PINON RIDGE MINING LLC
Van 4 Mine
Technical Revision No. 1 – Reclamation Plan
Permit No. M-1997-032

Project No. 12100.05

February 5, 2025

This Technical Revision (TR-01) reviews applicable historical reclamation plans and presents several proposed changes to those plans for the Van 4 Mine. The original Reclamation Plan (Exhibit D) was prepared in 1997 during initial mine permitting and is provided in Attachment A. An original Reclamation Plan map (Exhibit E) was prepared by Energy Fuels Nuclear, Inc. in August, 1998 and is shown as Figure 2 in this report. Denison Mines (USA) Corp. (Denison) reproduced this map in June of 2009 as part of the Environmental Protection Plan (EPP).

**Figure 6. Colorado DRMS
Standard Drawing No. 3
Concrete Shaft Closure**

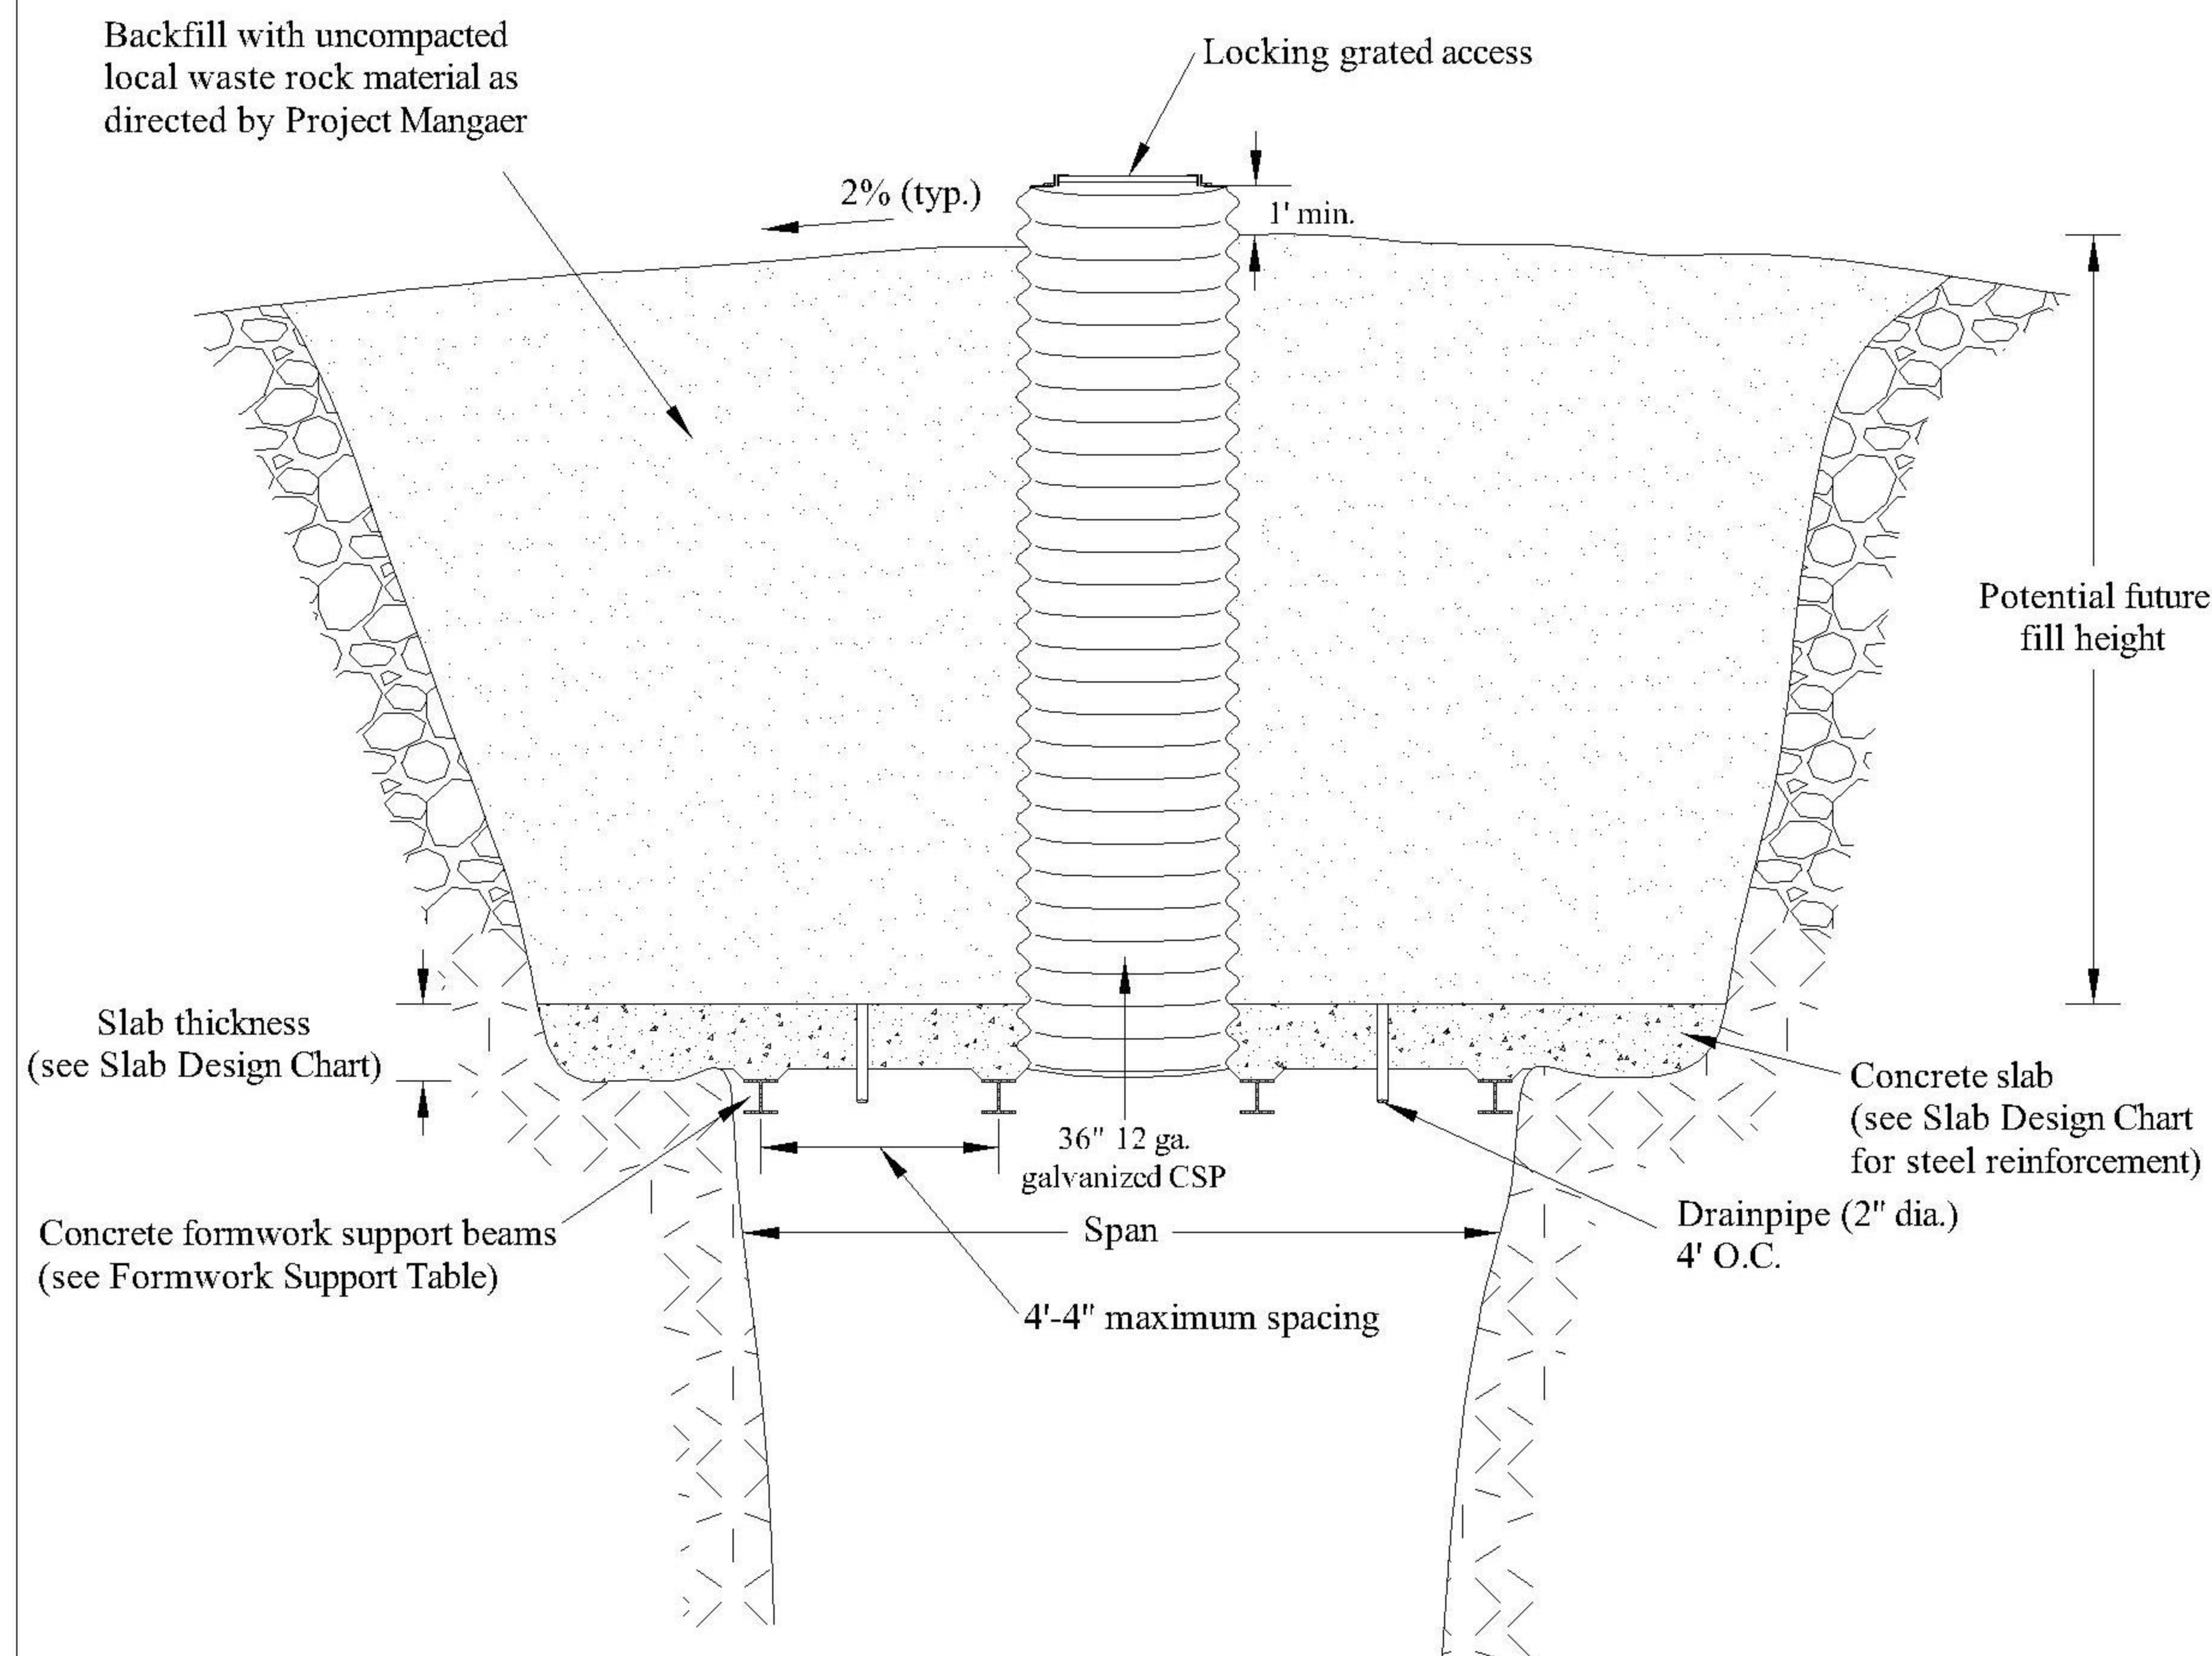
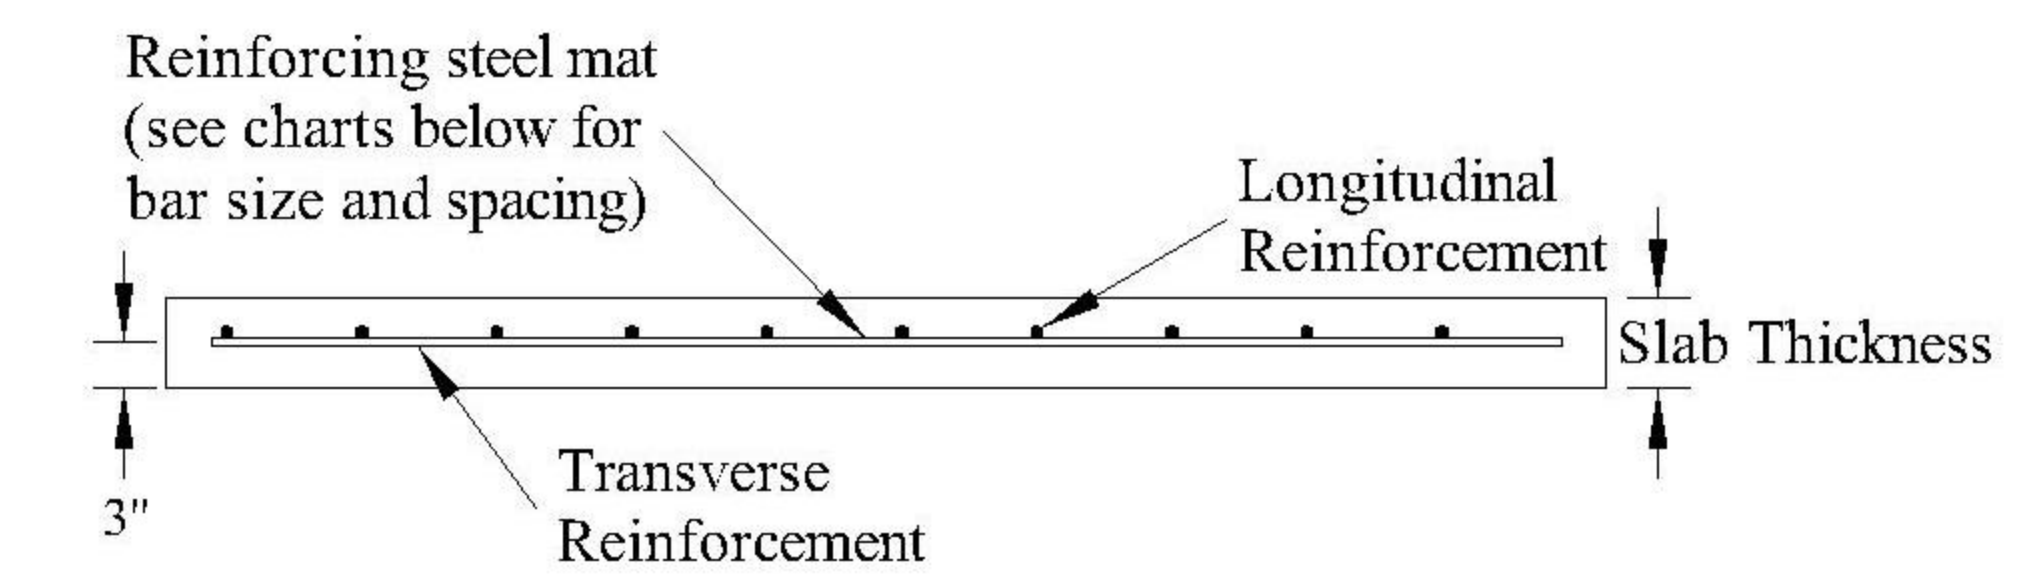
PRM proposes to close the production shaft using specifications under Standard Drawing No. 3 – Concrete Shaft Closure, with two key revisions: 1) complete the shaft cap closure directly on top of the existing concrete collar slab, and 2) do not construct an access manhole. Standard Drawing No. 3 is shown in Figure 6.

PRM proposes to close the vent shaft using specifications under Standard Drawing No. 3 – Concrete Shaft Closure, with two key revisions: 1) complete the shaft cap closure directly on top of the existing concrete collar slab, and 2) do not construct an access manhole. Standard Drawing No. 3 is provided as Figure 6.

The shaft cap will be constructed directly on top of the existing concrete slab that collars the top of the shaft. There are several reasons that support this construction method:

- The existing concrete slab that collars the shaft will provide the strength and stability required to support the proposed shaft cap design.
- The identified competent sandstone bedrock surface underlying the shaft collar is likely uneven and inconsistent in induration requiring significant preparation of this surface to support construction of the shaft cap. The removal of the existing concrete collar and slab, excavation to bedrock, and preparation of the bedrock surface will add significant time and expenses to the project as well as add complications to shaft stability and safety measures.

- Soils underneath the production shaft were likely compacted prior to slab installation and the slab has existed on site for 45 years with no evidence of subsidence or substantial weathering.

FIGURE 7-1. Production Shaft Cap Closure - Plan Schematic

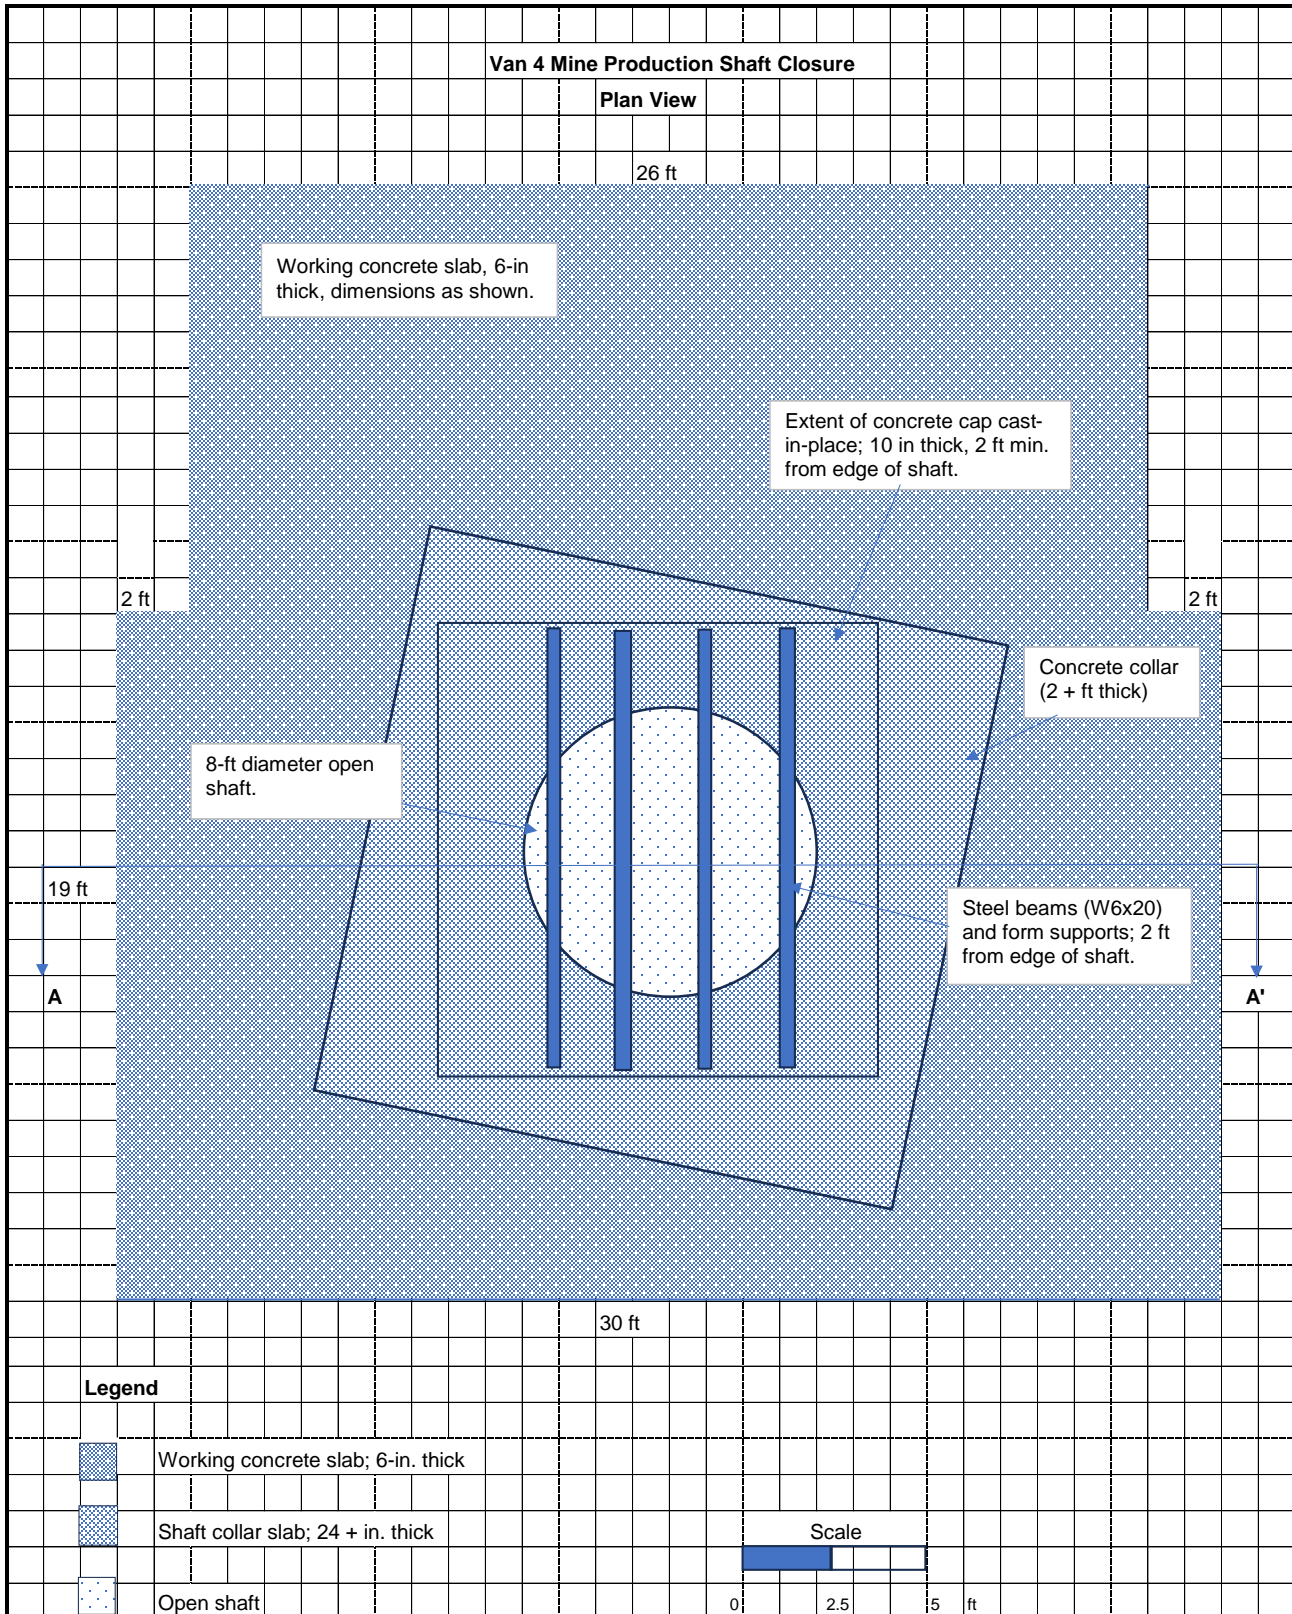
The proposed production shaft closure design is shown as plan and cross section schematics in Figures 7-1 and 7-2, respectively. Steel beam supports and concrete specifications were selected per guidance in Standard Drawing No. 3. The shaft span is 8 feet and 4 feet of fill height (depth of cover) is anticipated. Slab Design Charts on Standard Drawing No. 3 indicate that a “D” slab designation is expected and will require a slab thickness of 10-inches (0.83 ft). A “D” slab designation requires reinforced transverse rebar of #8 at 7-inch spacing, and longitudinal rebar of #4 at 11-inch spacing. Prior to concrete placement the beam and form framework will be sprayed with a protective sealant (asphalt based or similar product). Two 2-inch polyvinyl chloride (PVC) drain pipes will be installed through the cast-in-place slab.

- The metal grating currently covering the shaft and any other metal that protrudes from the shaft or near the shaft will be removed flush to or below the concrete slab surface.

- The existing concrete slab will be swept clean of debris.
- Any uneven surfaces in the concrete will be repaired with fresh neat cement.
- A pre-constructed metal framework consisting of four steel support beams (size: W6x20 or W6x25) and formwork (stay-in-place bridge decking or steel metal plate) will be laid in place on top of the concrete pad at equal distances spanning the shaft (see cross section A-A' plan view, in Standard Drawing No. 3 and Figures 7-1 and 7-2). The beams and support forms will extend at least 2 feet from the shaft opening in the concrete collar.

- The four corners of the outer-most beams will be anchored to the concrete slab with metal bolts.
- A wood form will be constructed encompassing the end of the beams and at a distance 2 feet from the shaft's edge (along the sides of the outside beams).

- Rebar reinforcement will be installed inside the form, in between and on the outside of the beams.
- The cast-in-place, 4,000 psi-rated cement will be poured to a depth of at least 10 inches inside the cap form. This should provide a cover of about 4 in over the top of the beams.

- Onsite soil and topsoil will be placed over the shaft cap not to exceed a depth of 4 ft above the cap. Six inches of topsoil will be applied. The graded slope will not exceed a steepness of 3:1.

FIGURE 8. Vent Shaft Existing Conditions - Plan and Cross Section A-A' Schematic

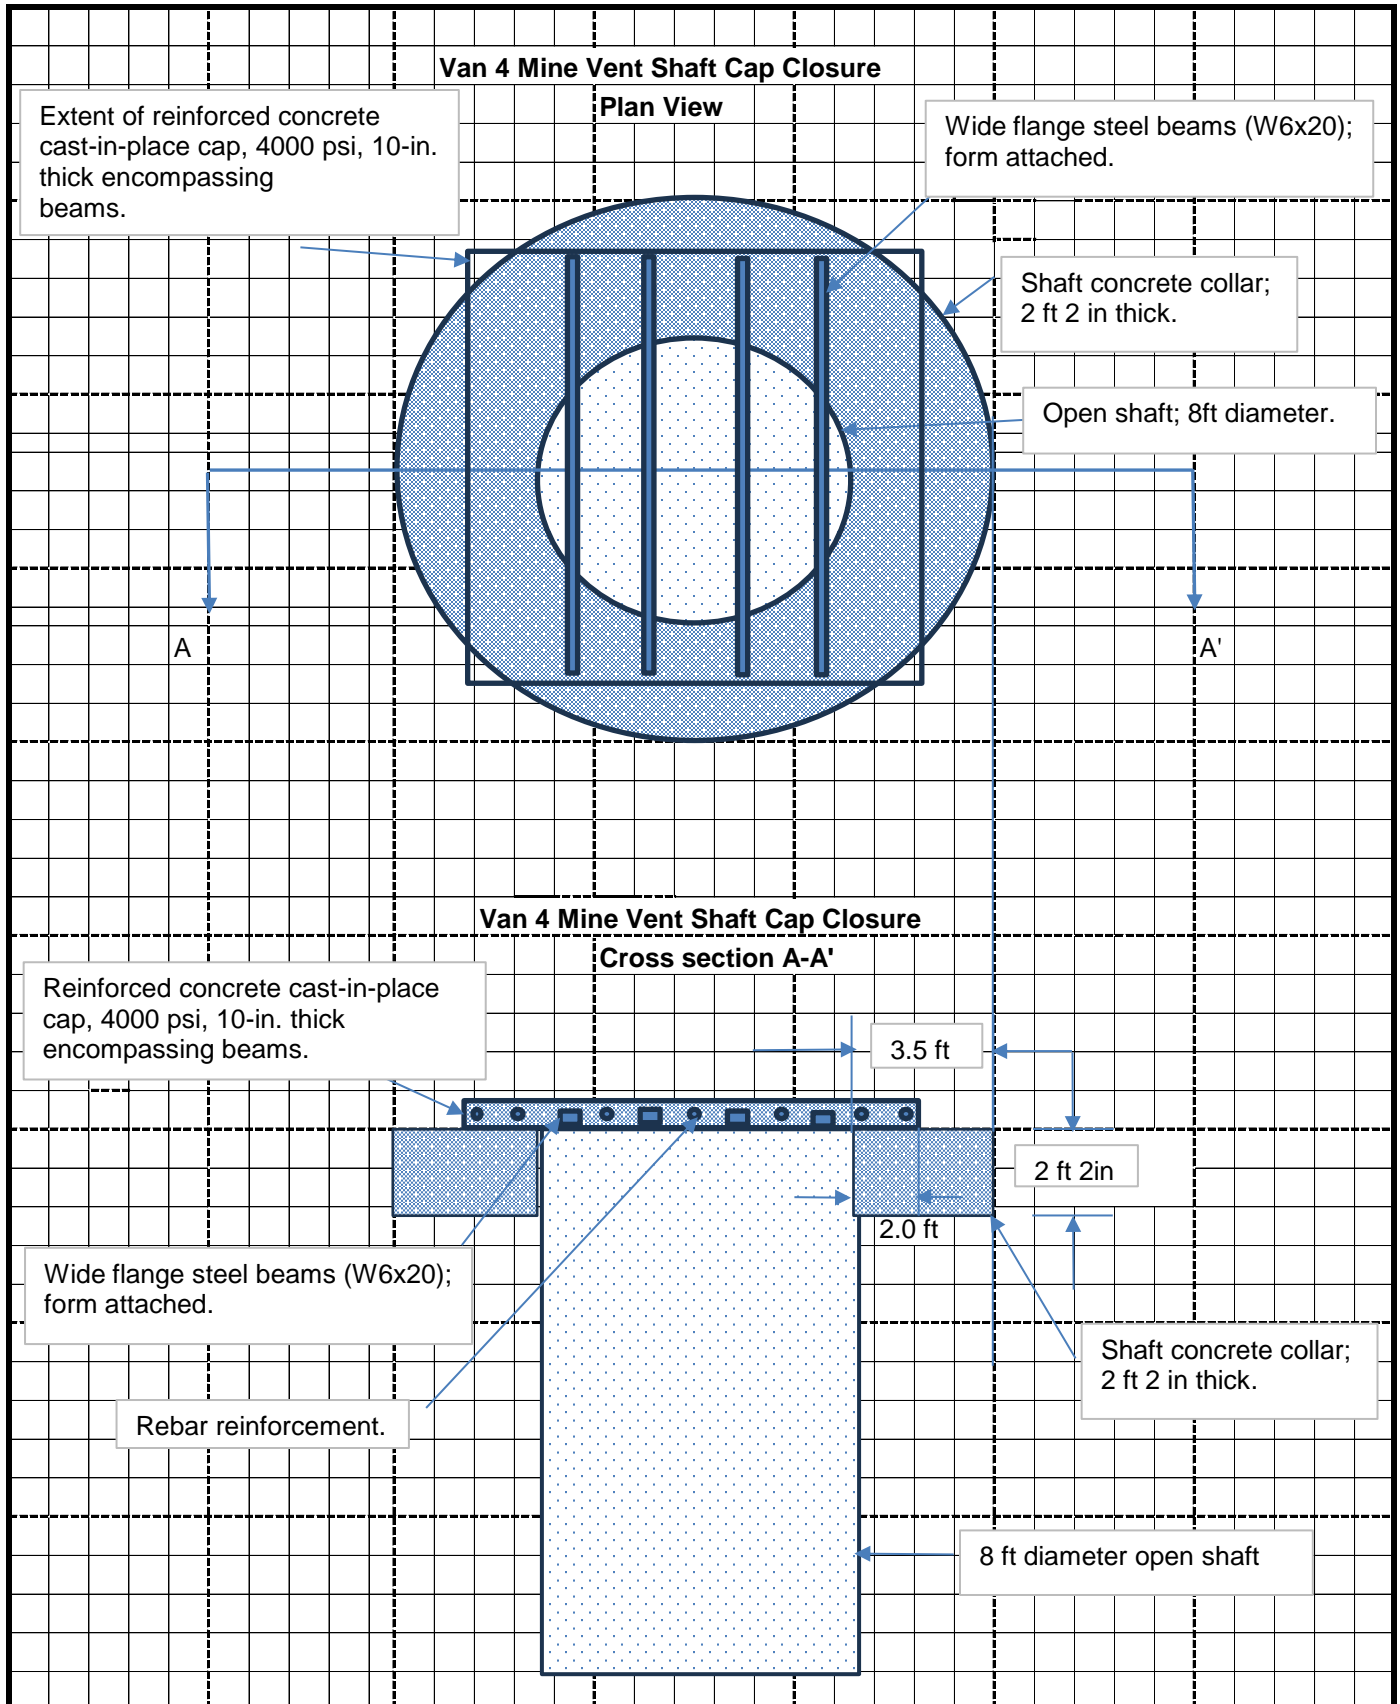
The proposed vent shaft closure design is shown as schematic drawings in Figure 8. Steel beam supports and concrete specifications were selected per guidance in Standard Drawing No. 3. The shaft span is 8 feet and 4 feet of fill height (depth of cover) above the finished cap is anticipated. Slab Design Charts on Standard Drawing No. 3 indicate that a “D” slab designation is expected and will require a slab thickness of 10 in. Four steel beams, W6x20 or W6x25 type, will be installed over the shaft, extending at least two feet beyond the edge of the shaft. A steel stay-in-place form (bridge decking) or solid plate steel will be fastened to the bottom of the beams providing the bottom form for cast-in-place cement placement.

The beams and form will be pre-fabricated offsite and laid in place over the shaft on top of the existing concrete slab. Each corner of the framework will be anchored to the concrete slab using anchor bolts. A “D” slab designation requires reinforced transverse rebar of #8 at 7-inch spacing, and longitudinal rebar of #4 at 11-inch spacing. Prior to concrete placement the beam and form framework will be sprayed with a protective sealant (asphalt based or similar product). Two 2-inch drain PVC pipes will be installed through the cast-in-place slab.

- Any metal that protrudes from the shaft or near the shaft will be removed flush to or below the concrete pad surface.
- The existing concrete pad and steel plating will be swept clean of debris.
- The steel plate covering portions of the concrete slab and open shaft will be left in place.
- A pre-constructed metal framework consisting of four steel support beams (size: W6x20 or W6x25) and formwork (stay-in-place bridge decking or steel metal plate) will be laid

in place on top of the concrete pad at equal distances spanning the shaft (see cross section A-A' plan view, in Standard Drawing No. 3, and Figure 8. The beams and support forms will extend at least 2 feet beyond the edge of the shaft on top of the concrete slab collar.

- The four corners of the outer-most beams will be anchored to the concrete slab with metal bolts.
- A wood form will be constructed encompassing the end of the beams and at a distance 2 feet from the shaft's edge (along the sides of the outside beams).

- Rebar reinforcement will be installed inside the form, in between and on the outside of the beams.
- The cast-in-place, 4,000 psi-rated cement will be poured to a depth of at least 10 inches inside the cap form. This should provide a cover of about 4 in over the top of the beams.
